**Quality Control Check Report**      Stage: After Plumbing & Electrical (Villas)

Bungalow no.	107	Stage	Project	Sl. No.	32909
Company	Nilgiri estates	Project	Nilgiri estate	Phase	II
Prepared by	P. Sai Kumar	Sign	[Signature]	Date	15/2/19
Project Manager	Srinivas	Sign	[Signature]	Date	15/2/19
Previous stage report no.	32445	Report filed and signed by PM?			
Additions & alterations sheet date	22/2/19	All pages signed by engineer & customer?			
Checked By MD on	MD Sign	For filing		<input checked="" type="checkbox"/> Yes <input type="checkbox"/> No	<input type="checkbox"/> Yes <input type="checkbox"/> No

Description	ELECTRICAL PLAN OF TYPE -AA2		
	QC CHECK PLAN		
Direction	N [Compass Rose]	Owners & Developers :	Modi Properties & Investment Pvt.Ltd.
		Project Name & Phase :	Night Estate
		Date :	02.09.17
		Prepared By :	Soham Modi
		Approved By :	[Signature]
		Scale :	N.T.S
		Promoted By :	Modi Properties & Investment Pvt. Ltd. Phone:-91-40-66333551

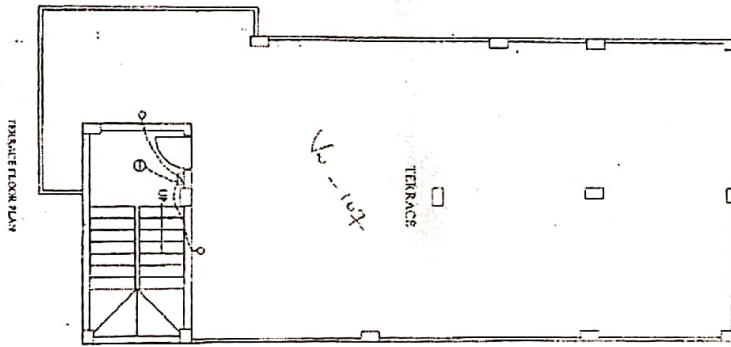
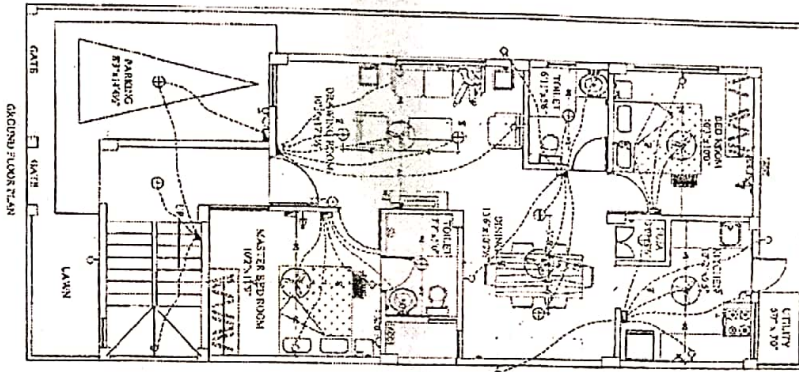
Remarks: ~~space~~ space packing for water lines of terrace not done.
